## Interactive comment on "Removal of radio N-nitrosodimethylamine (NDMA) from drinking water by coagulation and Powdered Activated Carbon (PAC) adsorption" by J. Chung et al.

Responses to Comments for Reviewer #1

Fig. 5.

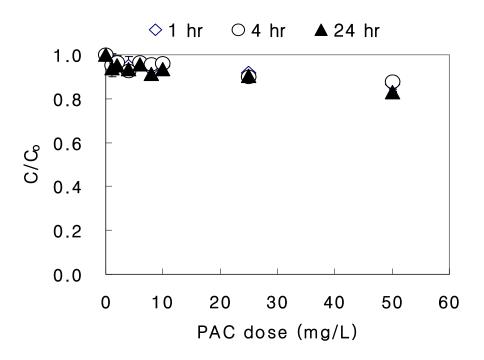
Comment 6. Figure legends in one or between figures should be generally identical (please unify their font and size). In particular, the legends in Figure 5 should be corrected: MF with out PAC and MF (UF) with out PAC Finally, a reviewer recommends author(s) to correct grammatical errors of the manuscript with native English speakers. If author(s) takes into account all the above factors, the article can be accepted for publication in the Journal. Response: Thank you for the valuable comments. We have revised those as suggested.
